Re: Response to Smiths Beach WA LVIA Peer Review (EPA Assessment No. 2340/ EPBC 2021/9141)

Smiths Beach 2014 Pty Ltd (the Proponent) welcomes the opportunity to respond to the “Smiths Beach WA LVIA Peer Review” dated 30 October 2025. We respect the importance of independent review; however, as outlined below, we have serious concerns with the Peer Reviewer’s opinions and approach.

Attachment: Response to Smiths Beach WA LVIA Peer Review

Figure 8 View from elevated rocks adjacent to the Cape to Cape Track looking north-west

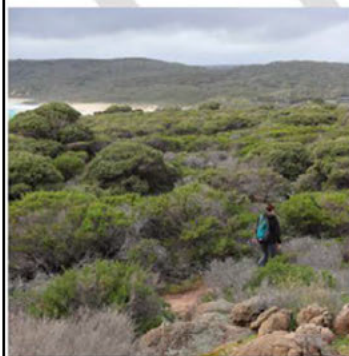
I did identify one location (S33°39'46" 115°00'24") (Figure 8) adjacent to the track with evidence of access that may afford a view towards the development. The view is from an outcrop with evidence of informal access by walkers. Figure 9 provides additional context with a walker illustrated on the track.

After review of the information provided and a site visit to this section of the track my opinion is that the visual interpretations presented by EPCAD (2021) provides a balanced assessment from the track.

- The Peer Reviewer notes that EPCAD assessed visibility from the Cape to Cape Track using ZVI mapping, line-of-sight analysis, cross-sections, and site photography, but comments that the cross-sections "only illustrate the context to the first built element" and were "confusing." The Reviewer nonetheless concludes that "the visual interpretations presented by EPCAD (2021) provide a balanced assessment from the track."

- EPCAD's analysis confirms that the Cape to Cape Track retains its natural character, with only limited, filtered visibility of built form. The VIA therefore meets the ESD work item 101 and aligns with the WAPC (2007) Visual Landscape Planning Manual.
